A Review of the Limerick Generating Station Severe Accident Risk Assessment

Review of Core-Melt Frequency

Brookhaven National Laboratory

Prepared for
U.S. Nuclear Regulatory
Commission

Figure 2.1.1 Crust Block source zone used in the LGS-SARA (taken from Appendix A, Figure 5 of LGS-SARA).

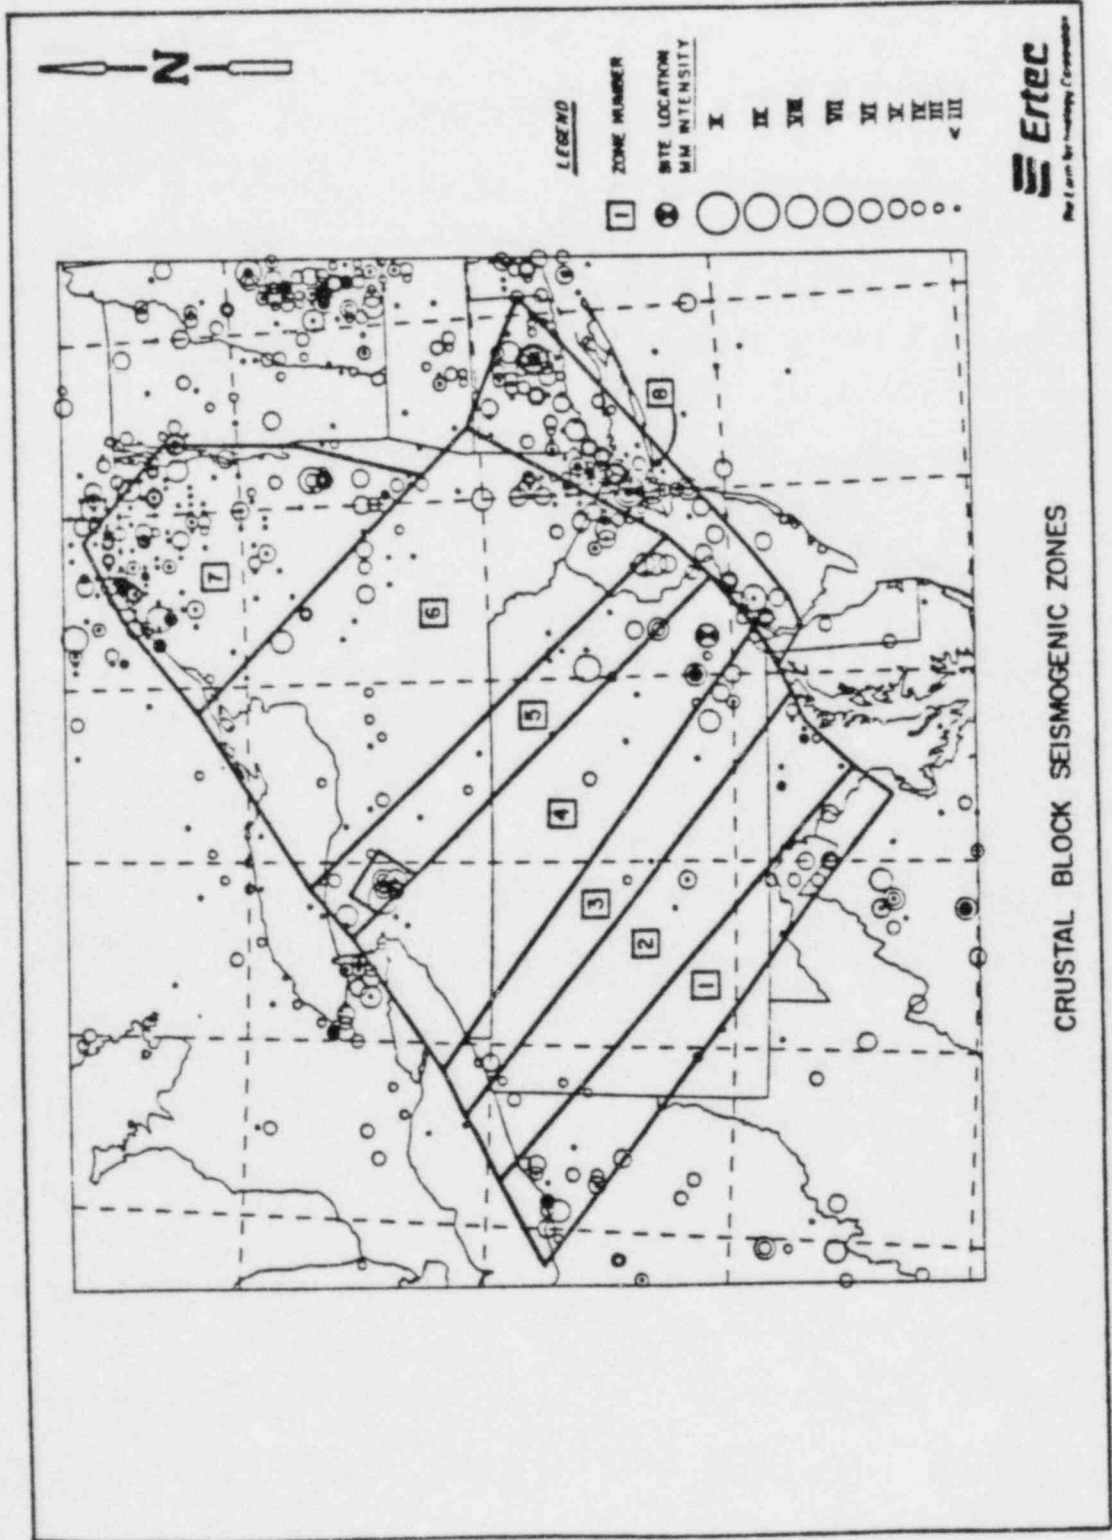
hypothesis (see Figure 2.1). Of these, Zone 8 is the dominant contributor to the hazard at the site. This hypothesis is questioned on two accounts. First, while the principle that large blocks of the earth's crust may control the seismicity in the region along their boundaries is reasonable, such a theory should correlate reasonably well with historic and instrumentally located seismicity. In general, this is not the case (see Figure 2.1).

As stated previously, Zone 8 is reported to have the greatest contribution to the site hazard. A review of Figure 2.1.1 indicates that the closest proximity of Zone 8 to the LGS-SARA site is approximately 30-40 miles. This fact alone explains to a large extent why the hazard curves derived for the Crustal Block hypothesis produced the lowest frequencies. It is further noted in Figure 2.1.1, which also shows the distribution of seismicity to 1980, that the northwest boundary of Zone 8 appears to be inconsistent with the pattern of earthquake occurrences in southern New York, New Jersey, and eastern Pennsylvania. At the meeting at SMA, it was learned that Zone 8 was modeled to represent the Triassic Basin. The inconsistent delineation of Zone 8, with respect to local seismicity patterns, may be attributed to two factors. The LGS-FSAR⁽⁶⁾ reports that Limerick is in the Triassic Lowlands, suggesting that the northwest boundary of Zone 8 should be moved toward the plant. This would also be consistent with the distribution of seismic events in the region (see Figure 2.1.1).

A redefinition of Zone 8 in the Crustal Block hypothesis that places the LGS site within its boundaries is judged to have a moderate impact on the estimated hazard curves (i.e., at least a factor of 2). The consequences of this change on the mean frequency of core melt is estimated to be small (i.e., a factor of 2 or less). However, a moderate increase in the median core melt frequency is considered possible.

Figure 2.1.2 Comparison of various historical seismicity curves and the LGS-SARA seismicity curves from Appendix A for sustained-based peak acceleration for the Decollement and Crustal Block, $M=5.5$ seismogenic zones.

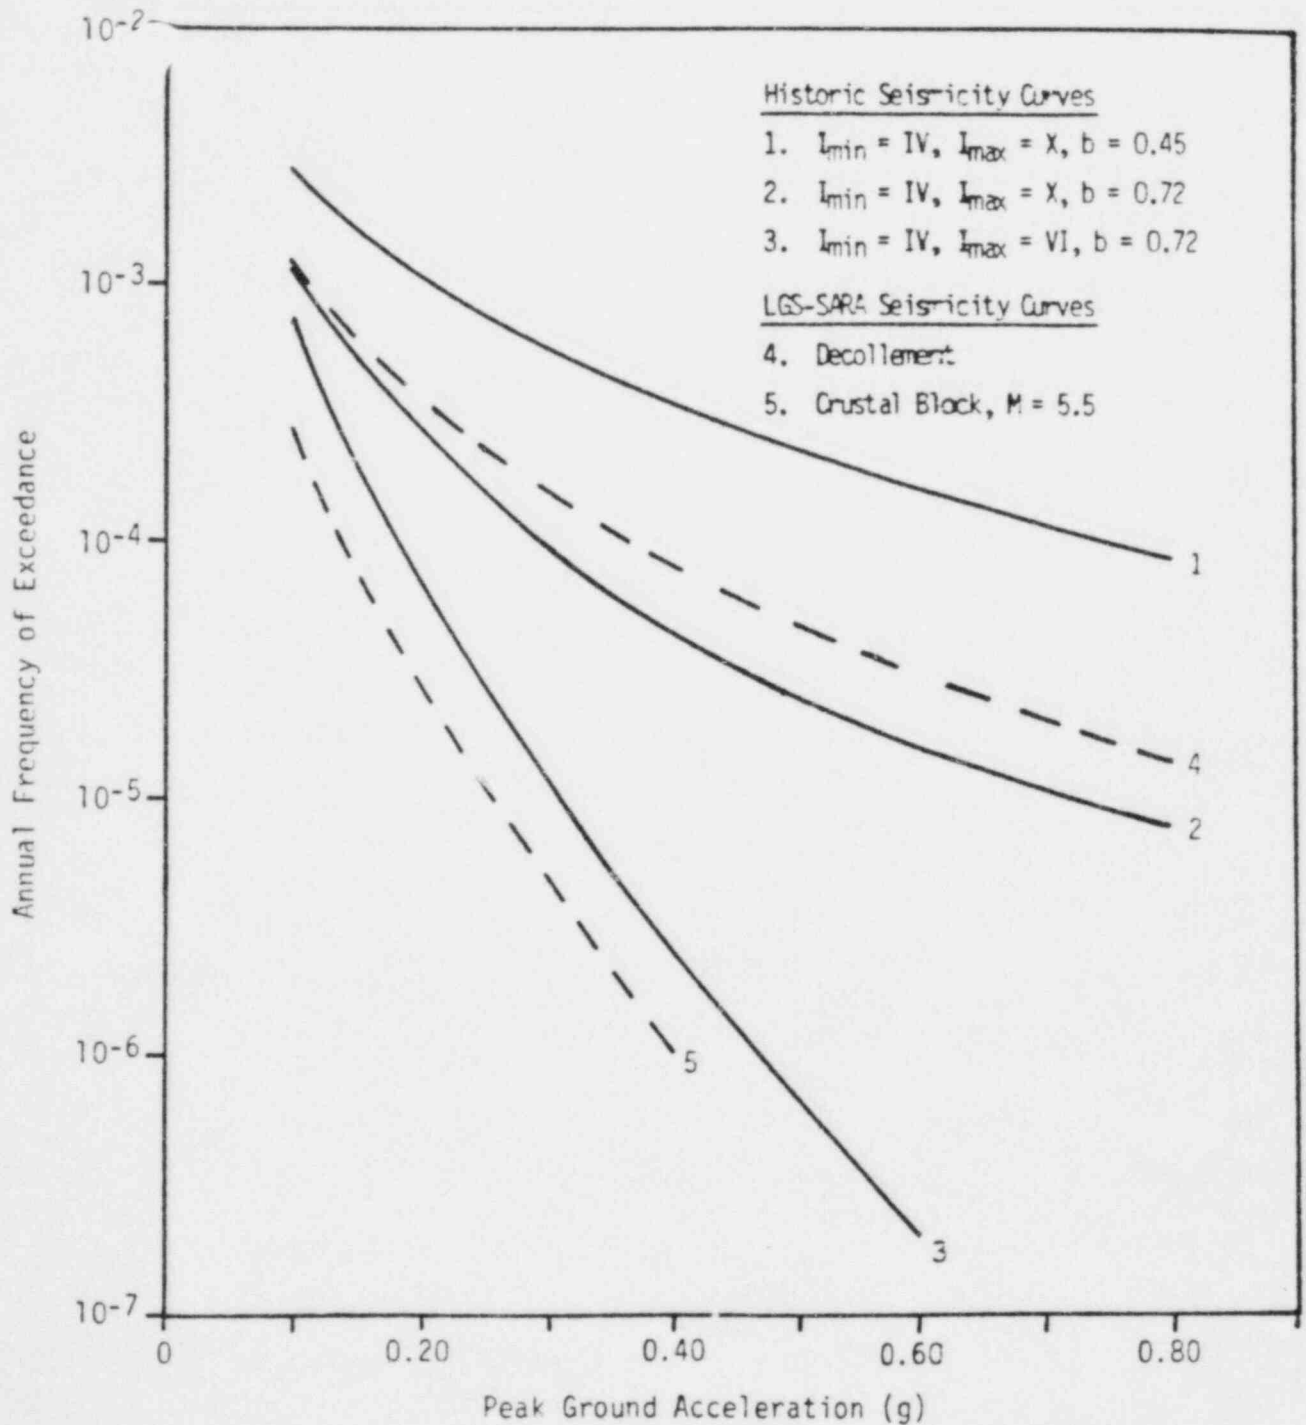
The result of this computation, using I_{max} of VI, is shown in Figure 2.1.2 with selected curves from the LGS hazard analysis. The historic seismicity curve compares to accelerations around 0.10g from the results obtained from the Decollement and Piedmont zones to the lower frequencies estimated by the Crustal Block zone. These observations suggest that the overall frequency of events producing accelerations of 0.10g is reasonably well described by the Decollement and Piedmont zones and the Crustal Block zone, $M=6.0$, to within a factor of 2. Since the assumed maximum intensity felt at the site is MMI VI, the historic frequency curve falls off sharply.

the same step that was taken in the probabilistic seismic hazard analysis. A maximum intensity of X was assumed, which corresponds to a large-magnitude ($\approx M7.0$) event occurring very near the site. The result of estimating $f(I)$ in equation 2.4 and calculating $v(A>a)$ for a maximum intensity of X , is also shown in Figure 2.1.2. This assumption allows the possibility of high accelerations associated with large events to occur. In general, the site intensity curve tracks the trend of the Piedmont and Decollement seismicity curves quite well.

As a final estimate based on the historic distribution of ground motion at the LGS, a seismicity curve is estimated assuming a Richter b -value of 0.45 which corresponds to the 0.90 value used for earthquake magnitude in the LGS-SARA. Again, a maximum intensity MMI X is assumed. The hazard curve for this case is shown in Figure 2.2. The effect of assuming a b -value of 0.45 (equivalent to 0.90 for the magnitude scale) results in a factor of four increase in the hazard.

Figure 2.2.1 Piloted ignition of EPR/Hypalon cable under various external heat flux.

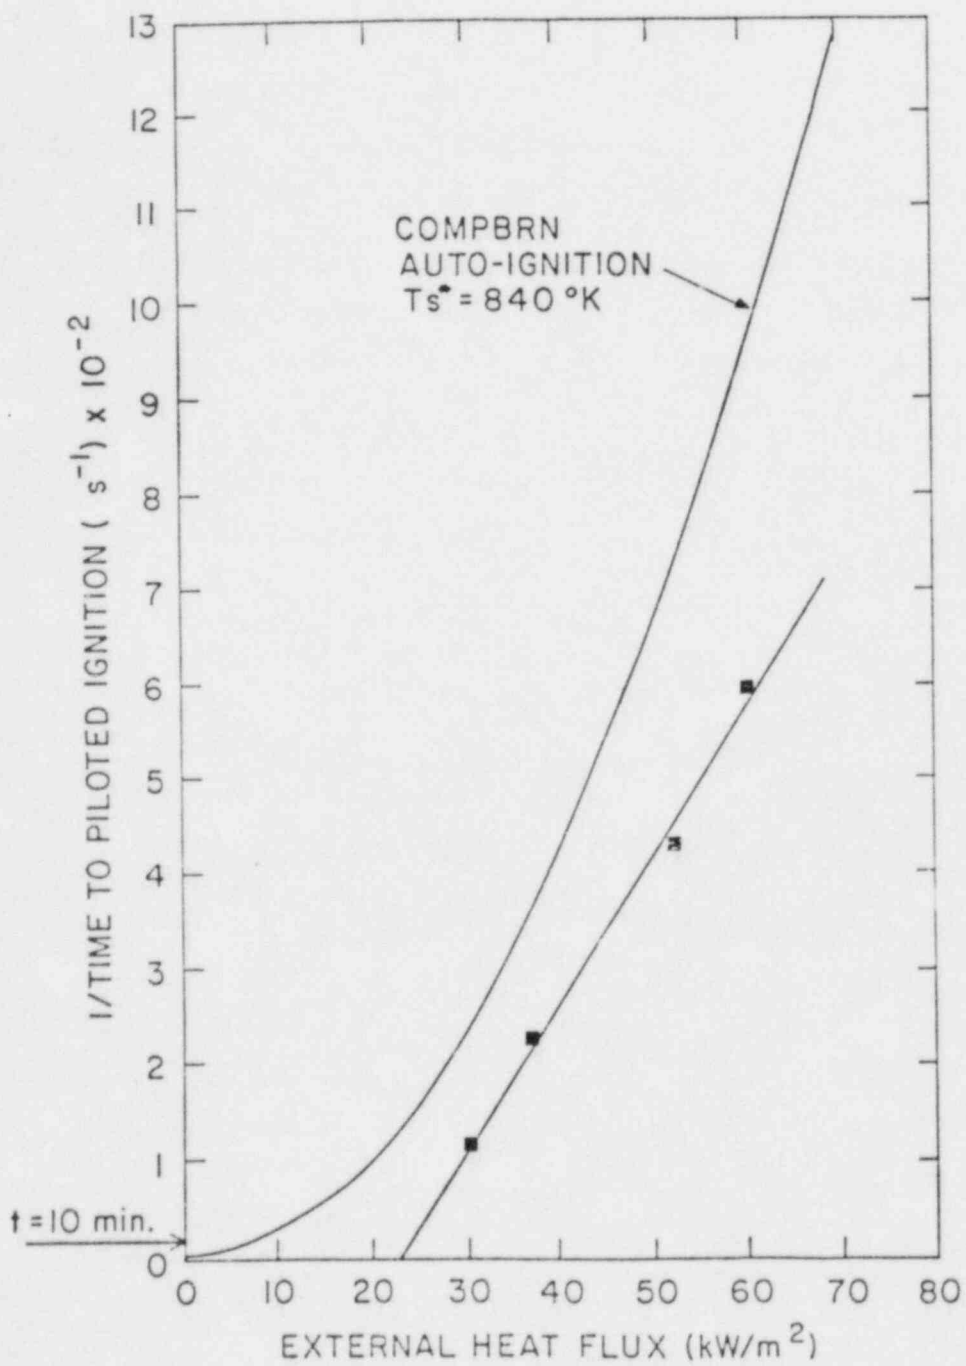
Figure 2.2.1 (attached) shows test data⁽¹²⁾ for the inverse of time to piloted ignition plotted vs external heat flux for EPR/Hypalon cable. The slope of the straight line is $1/E$. Also plotted is the ignition time model, Eq. (2.4), using a critical spontaneous ignition temperature of 840°K. The COMPBRN model is more conservative than even the piloted ignition data, especially for low levels of external heat flux, i.e., a given external heat flux will give an earlier time to ignition than the data. Also, while the data show no ignition below a heat flux of about 20 kW/m², the model predicts an ignition time for all values of heat flux. The 10-minute ignition time for stage-two self-ignited cable raceway fires is indicated for reference.

Figure 2.2.2 Fire suppression model.

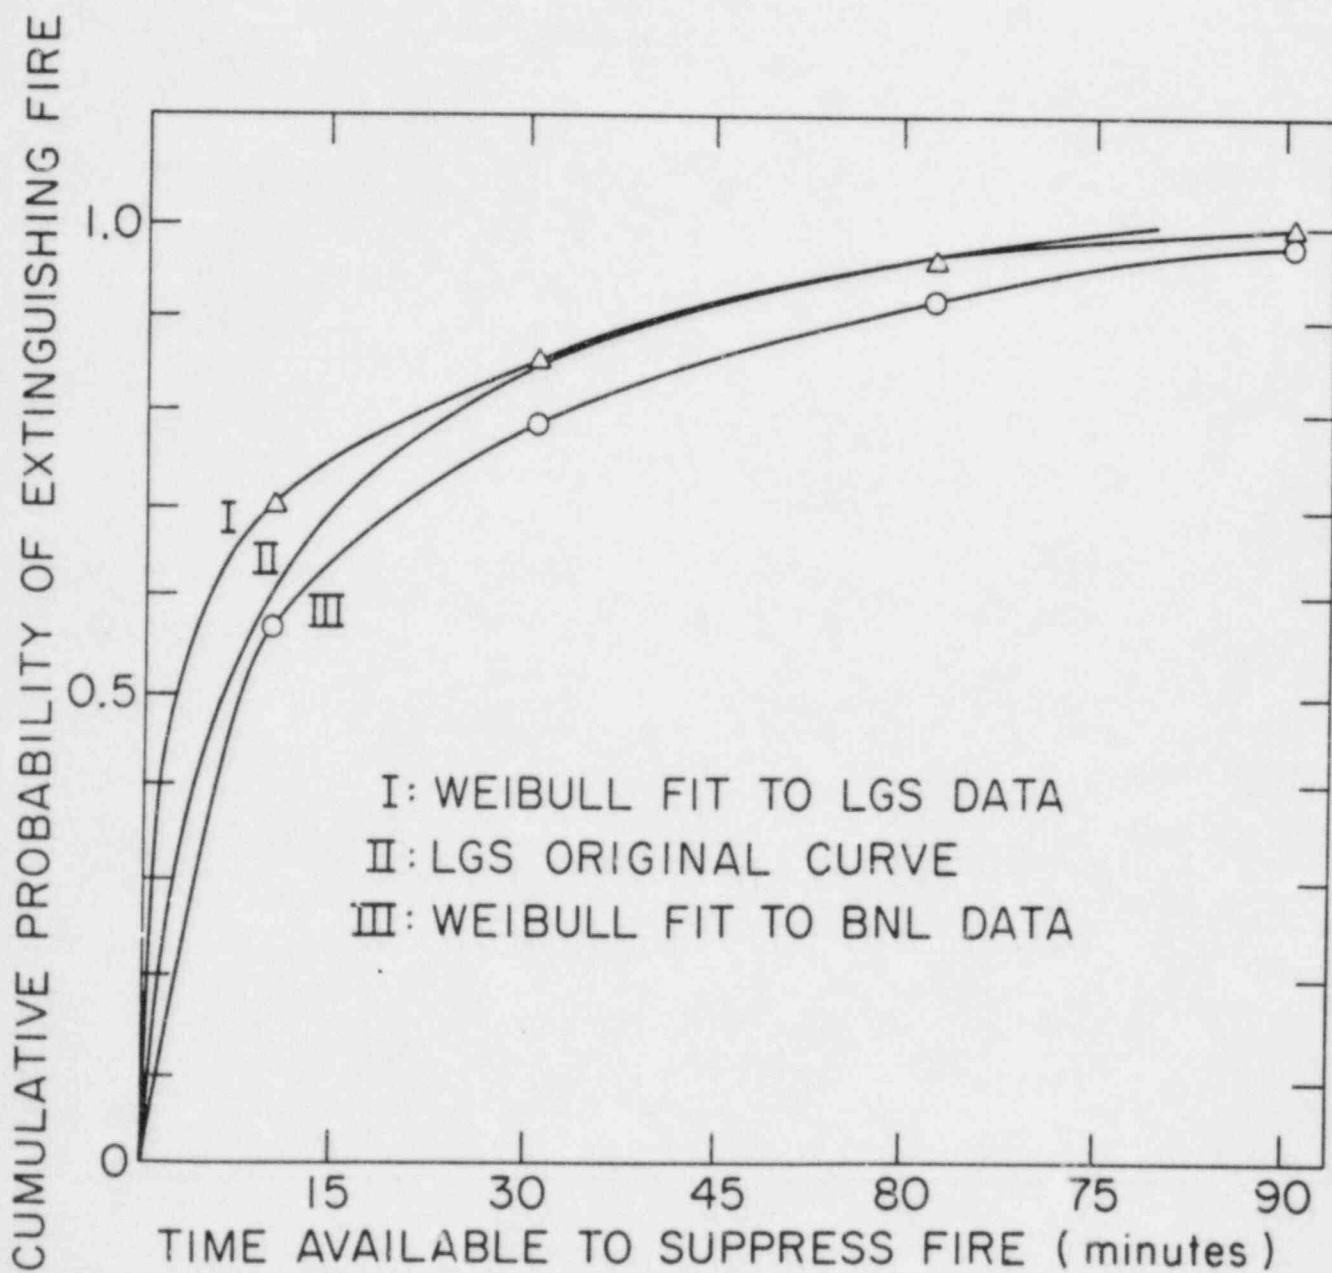
The estimated (σ, η) values for the BNL and the LGS data are (0.615, 13.5) and (0.458, 6.83), respectively. A comparison of the original LGS curve with the modified LGS and the BNL curves is given in Figure 2.2. In the time interval of 30 to 75 minutes, Curve I obtained by the Weibull fit to the LGS data is essentially the same as Curve II, obtained by the "eyeball fit" in the LGS report. Outside the above interval, the difference observed is not expected to result in any significant change in the final fire PRA results. However, comparison of Curve III obtained by the Weibull fit to the BNL data shows that the LGS estimate of suppression success probabilities is higher at all times.

Figure 3.1.2 Reduced fault tree for failure to scram.

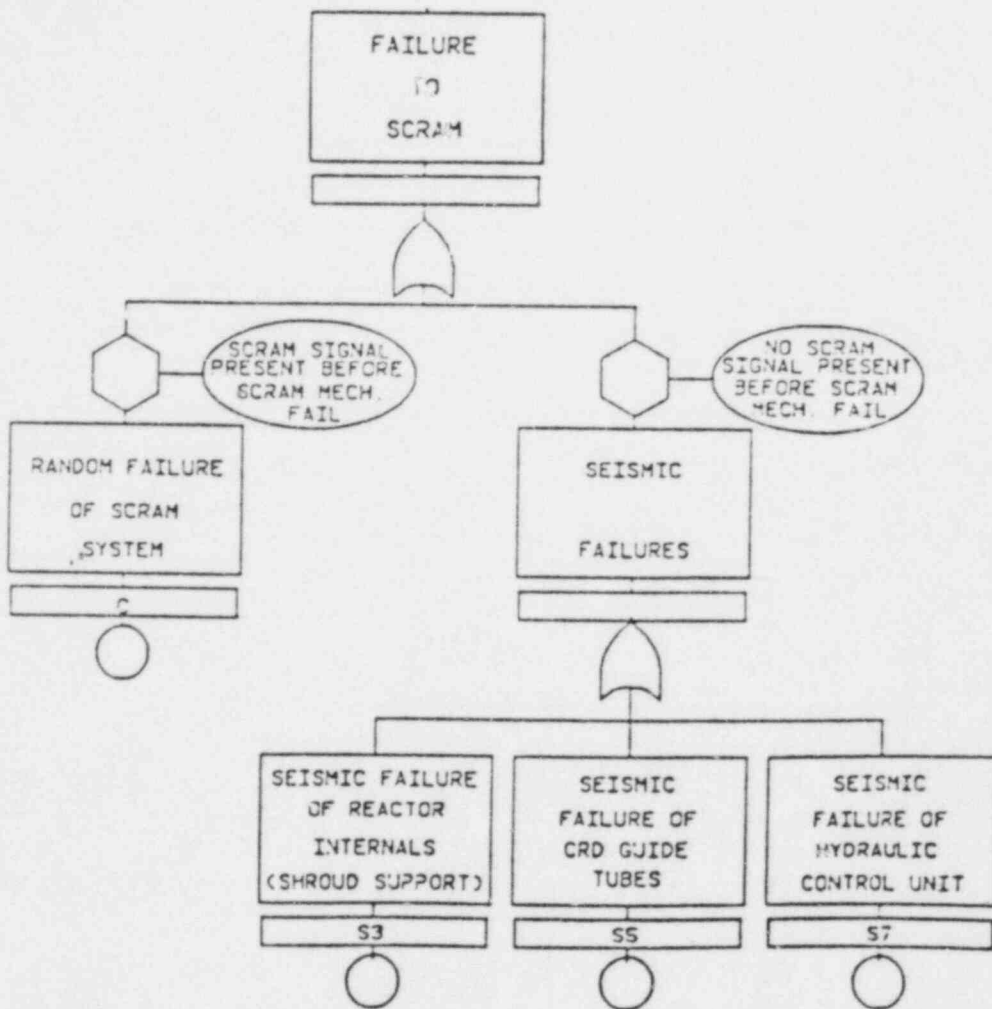
A telephone conversation with PECO revealed that the PC_R is a judgmental factor applied to the seismic failure of the reactor internals and CRD guide tubes (see Figure 3.1.2). PECO stated that failure of the CRD guide tubes or the reactor internals due to an earthquake would cause a failure to scram only 20 % of the time. Since information on how this PC_R value is obtained is incomplete, it is difficult for BNL to judge its validity.
